REQUEST FOR PROPOSAL

Project Title: Cooley Laboratory Renovation
Location: Montana State University

PPA No.: 10-0023
RFP No.: 61
Date: July 23, 2012

ADD SPRING MOUNTS TO PIPE
 RISERS

① PARTIAL PENTHOUSE MECHANICAL PIPING PLAN

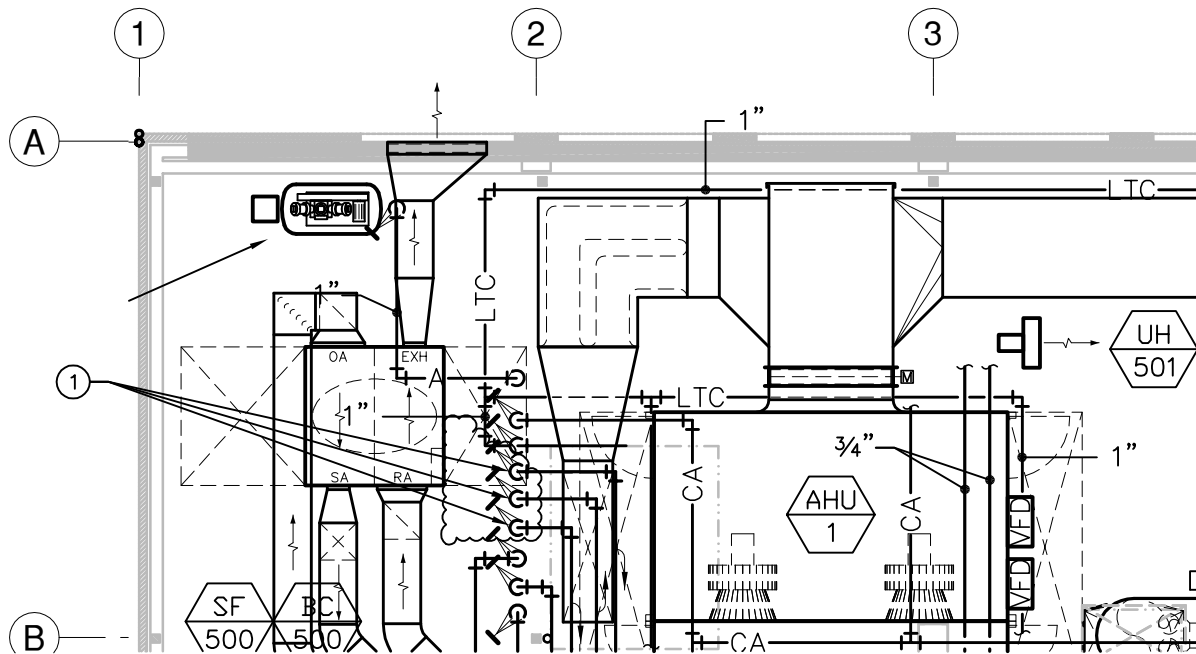
NOTE:
 ① INSTALL SPRING MOUNTS UNDER PIPE SUPPORT CLAMPS IN PENTHOUSE FOR 4" CLEAN STEAM, 4" HEATING WATER SUPPLY AND RETURN (HWS/HWR) PIPE RISERS. SEE DETAIL #2, THIS SHEET.

② PIPE RISER SPRING MOUNT DETAIL

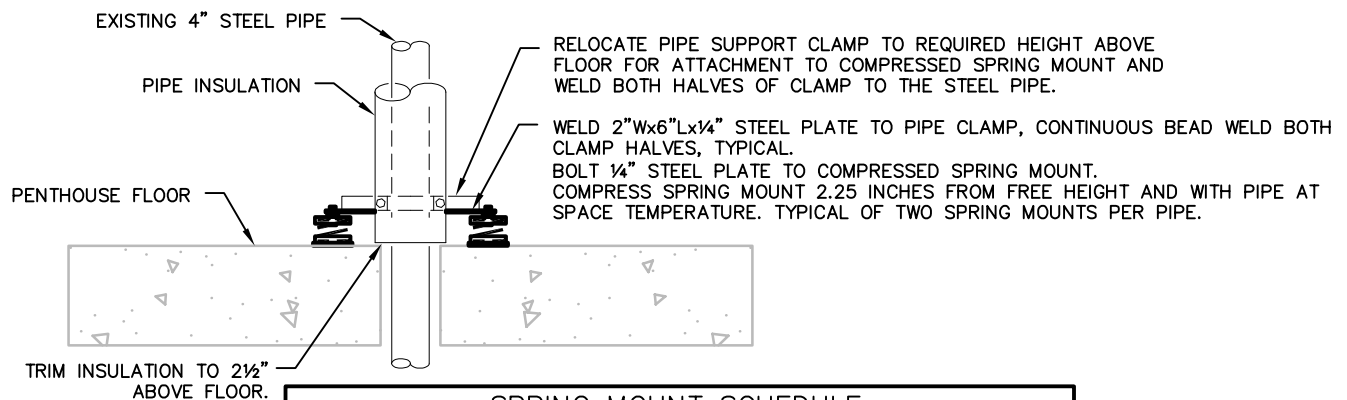
PROVIDE SPRING MOUNTS @ PENTHOUSE PIPE RISERS (3) LOCATIONS

- Provide Spring Mounts to Penthouse Pipe Risers
1. Clean Steam per schedule attached.
2. Heating Water Supply per schedule attached
3. Heating Water Return per schedule attached
